Town of Berthoud Planning Commission
Town Hall
807 Mountain Avenue
Thursday, March 23, 2023, at 6:00 p.m.

STAFF REPORT: HARVEST 47 PRELIMINARY PLAT

February 13, 2023 Response To Comments Regarding The Harvest 47 Subdivision Plat Dated 01.16.2023.

Sheet 1 of 2

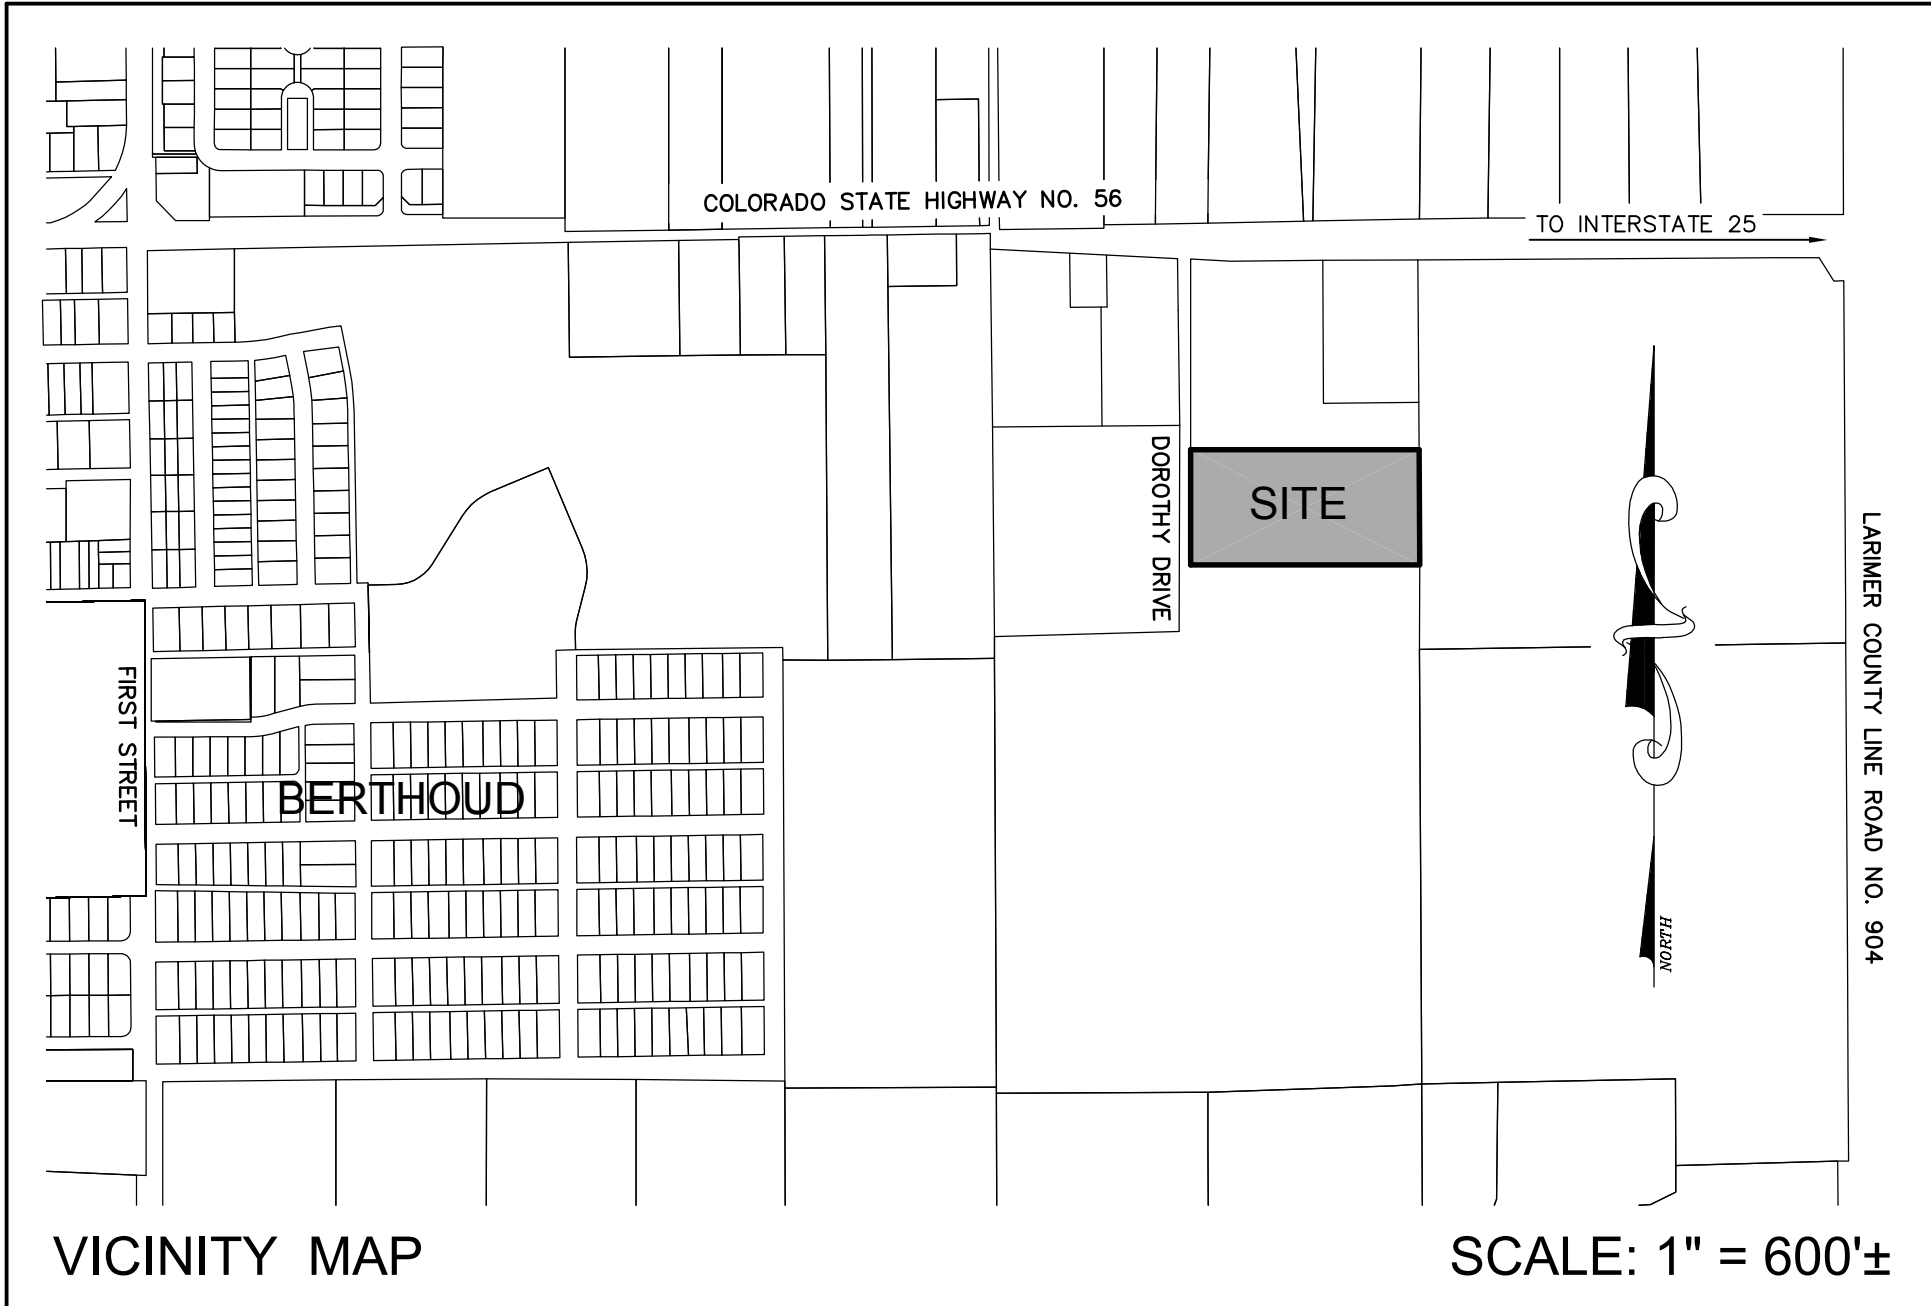
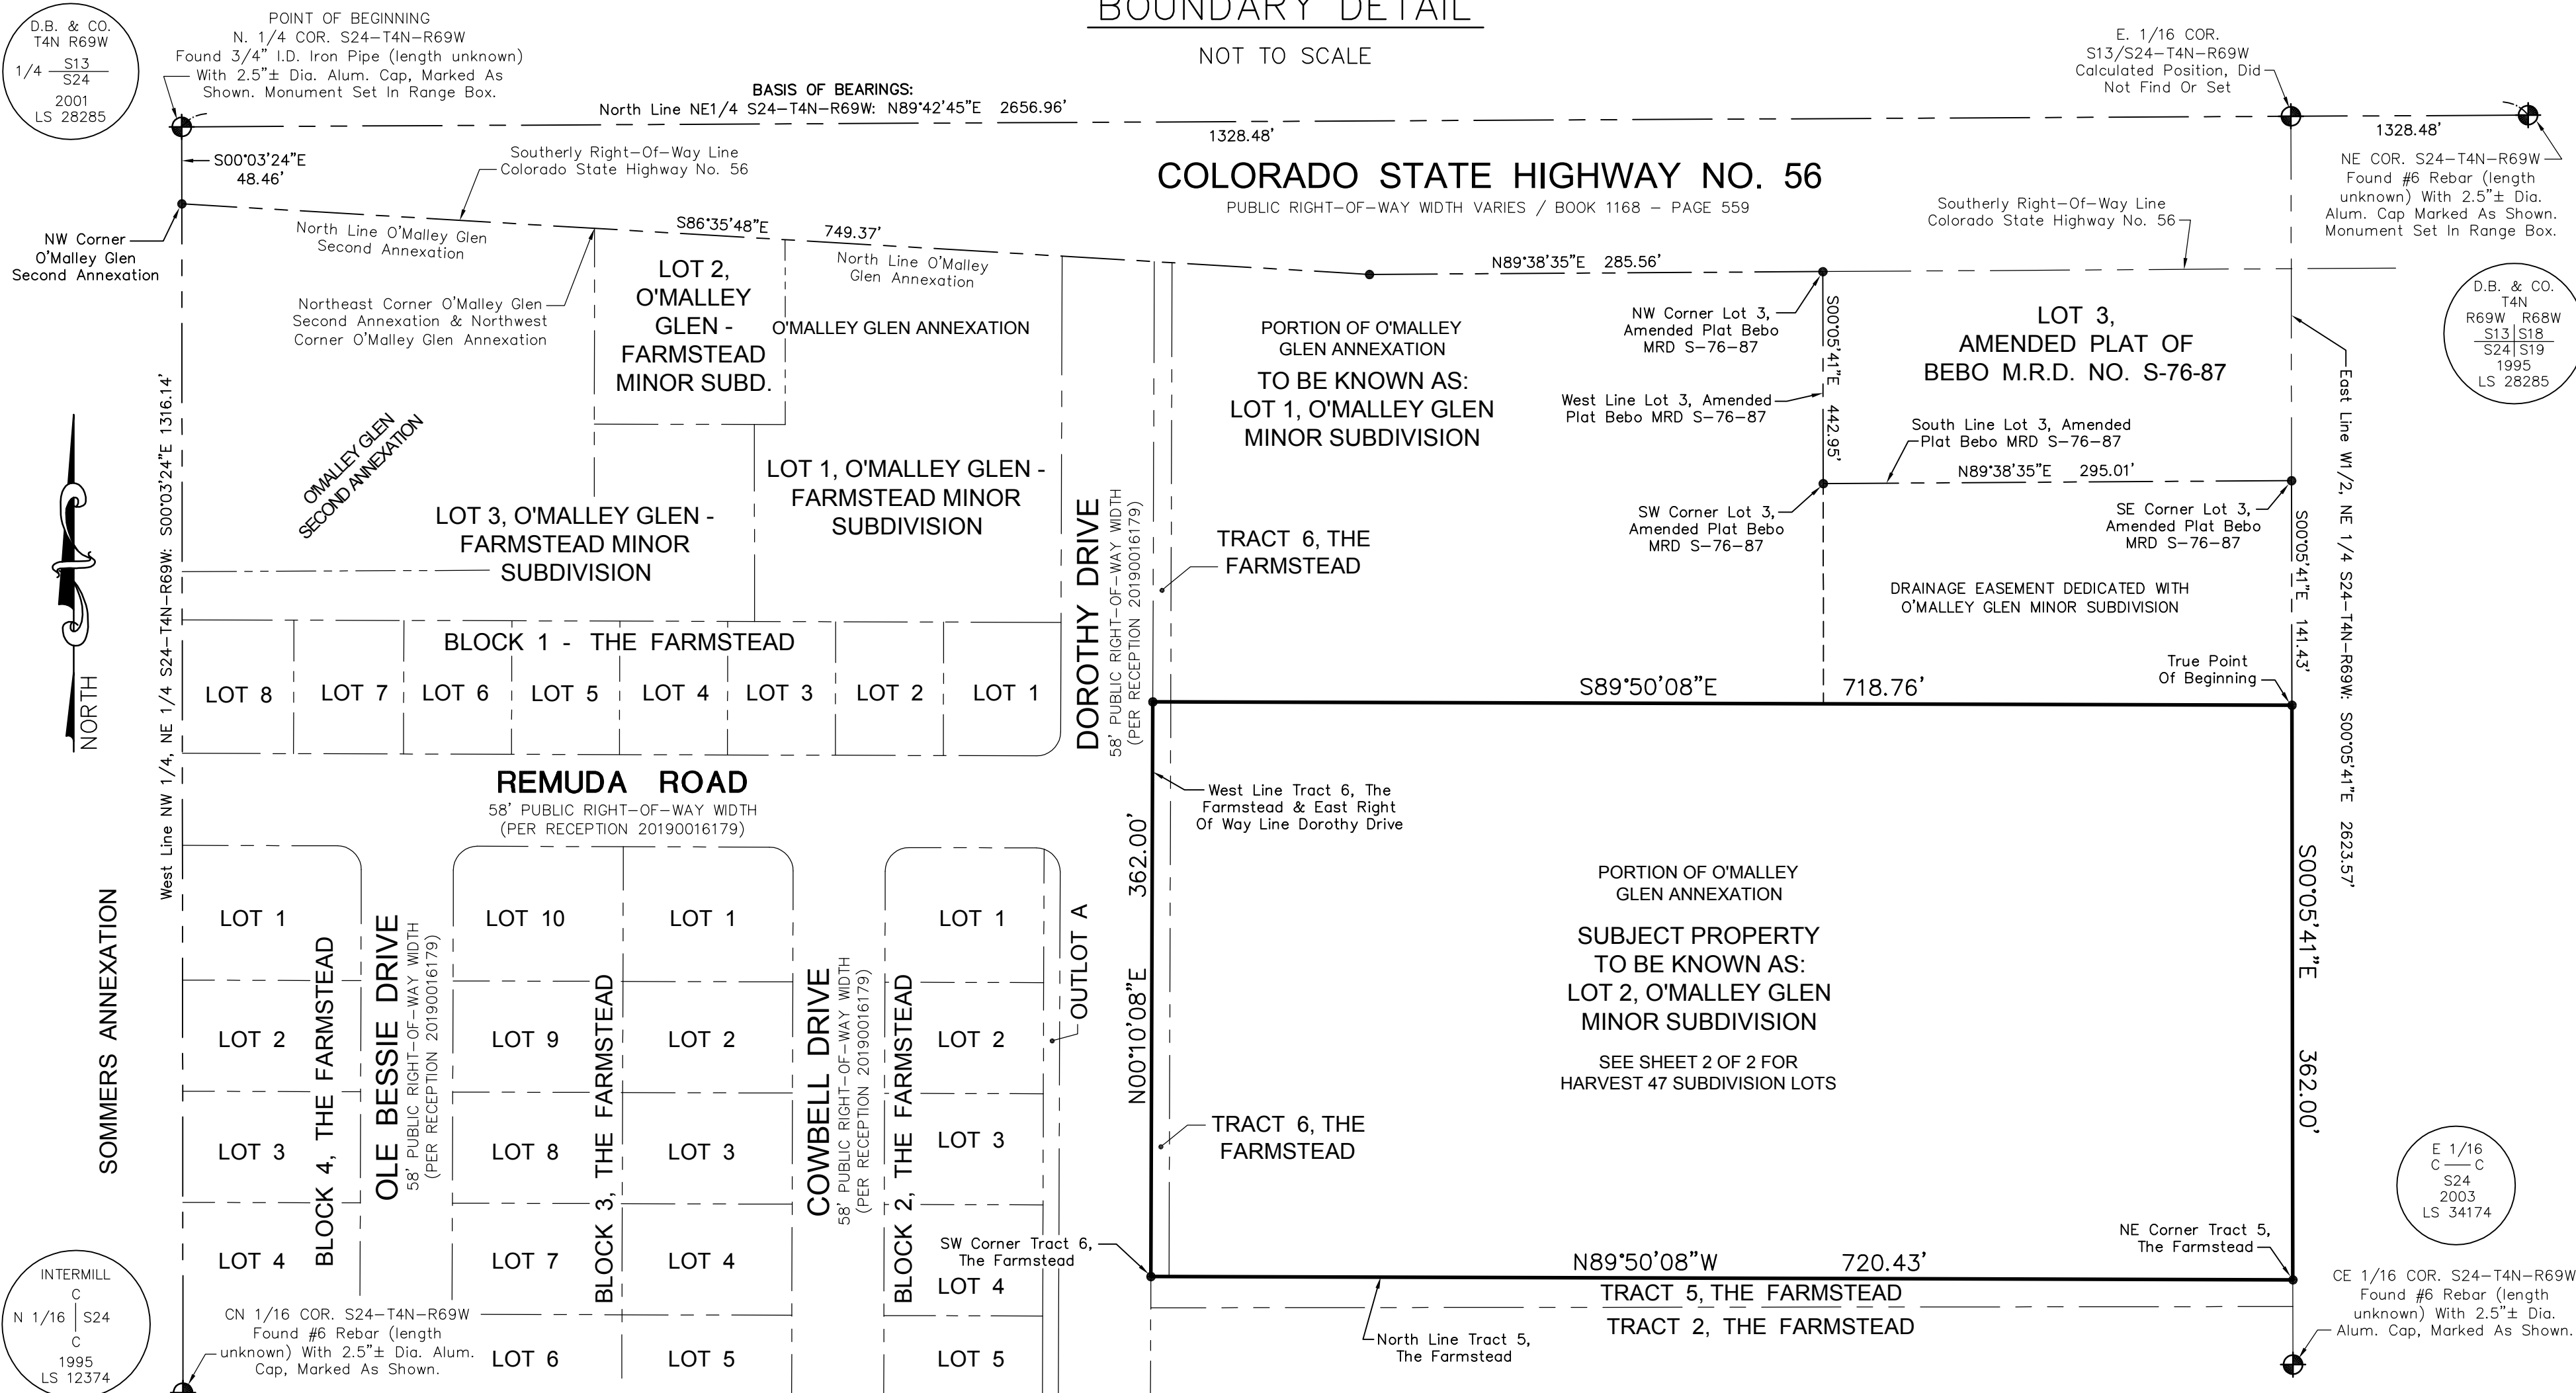
1. This document will be recorded with the county, so please include the County Certificate as previously shown. (RESPONSE: The certificate has been added.)
2. The Basis of Bearing Statement should be able to be a standalone statement and therefore must include the bearing and not just a reference to a recorded plat. (RESPONSE: The Basis of Bearings Statement has been corrected.)

Sheet 2 of 2

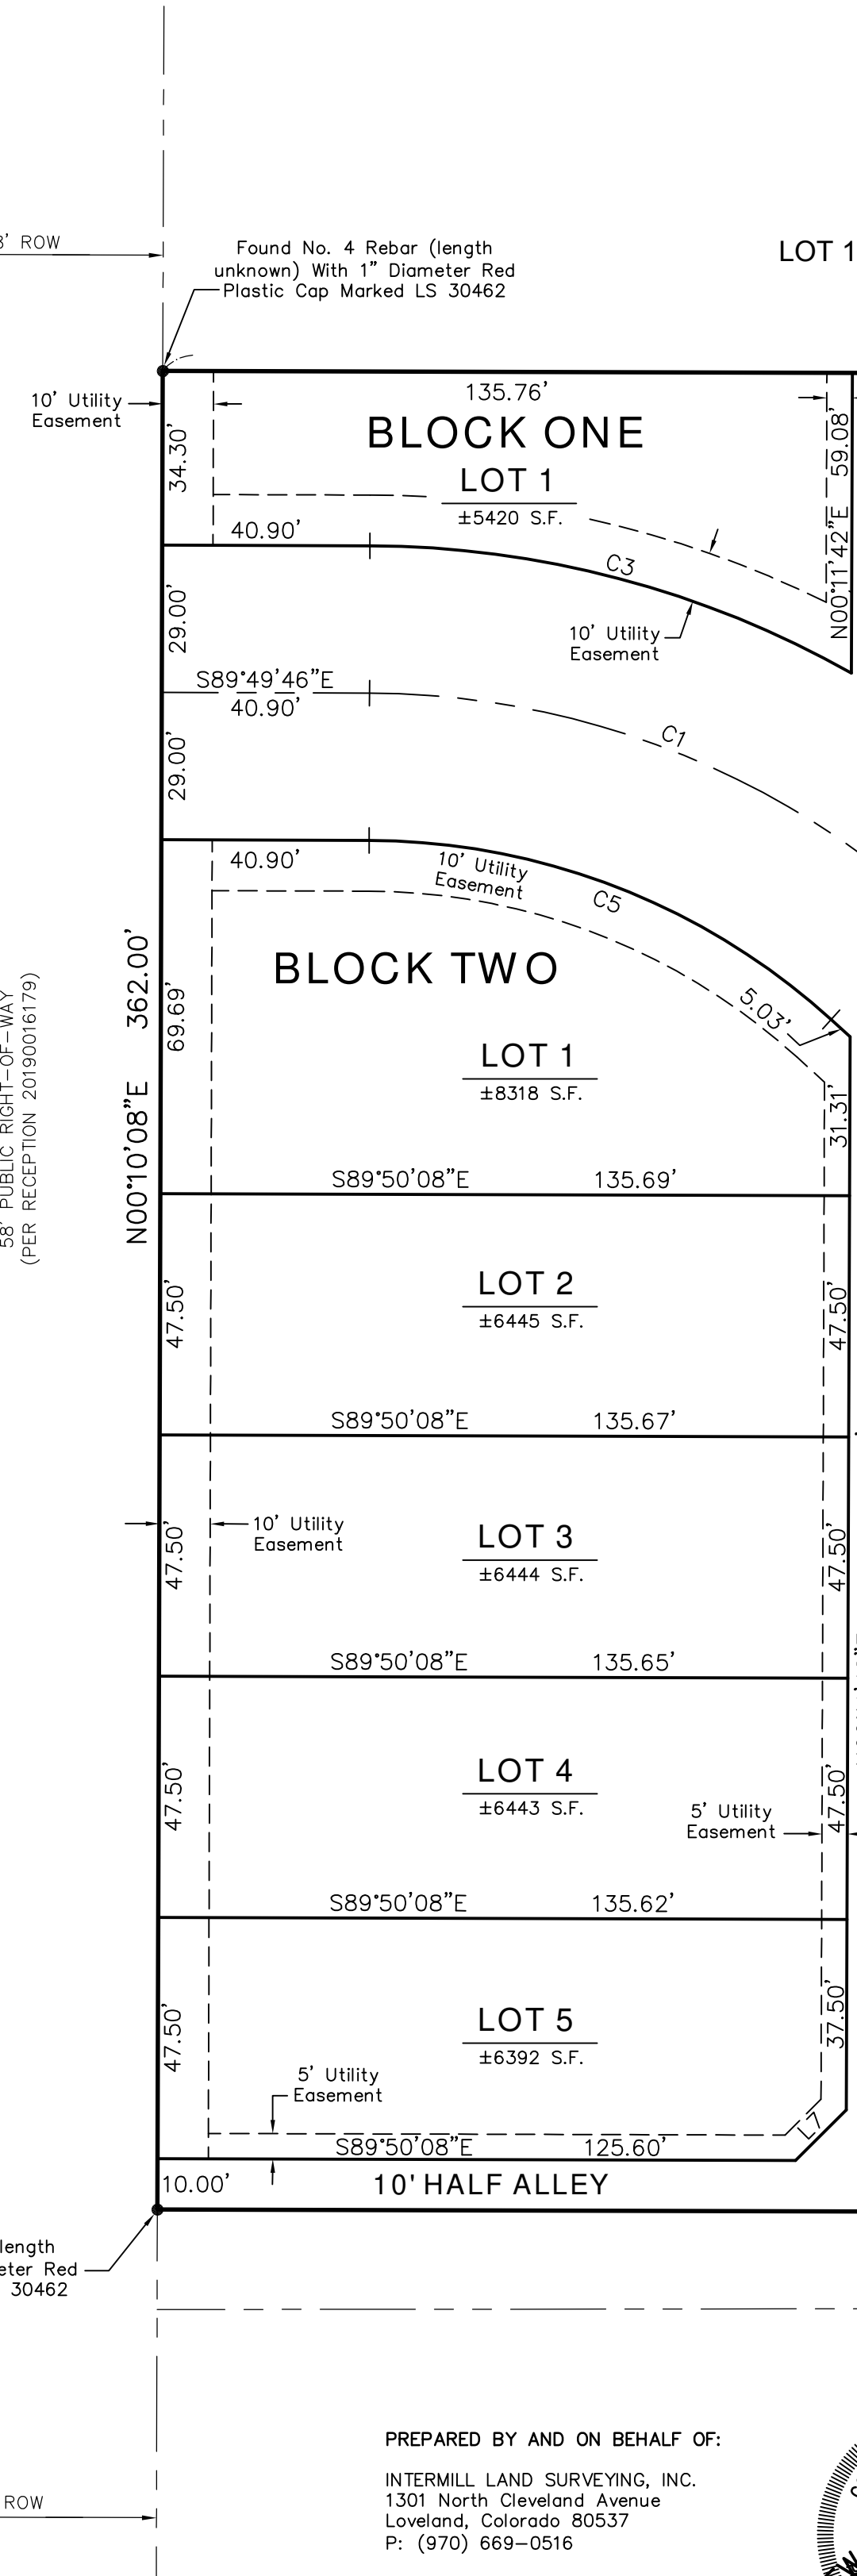
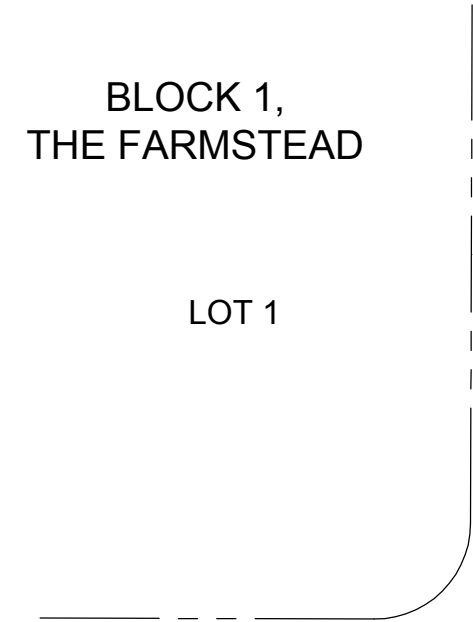
1. Check/verify the southerly plat boundary dimension. The "Farmstead Second Filing" (under current review has this line listed as 720.38'. (RESPONSE: Both plats (Harvest 47 & Farmstead Second Filing) indicate that the West property pin on that line is to be set. Both distances appear to be calculated. Our field crew has gathered additional right of way control information. We have revised the distance on the South line of the Harvest 47 Subdivision to 720.43'. That distance differs from the Farmstead Second Filing distance by 0.05'. We feel that difference is within acceptable tolerance.)
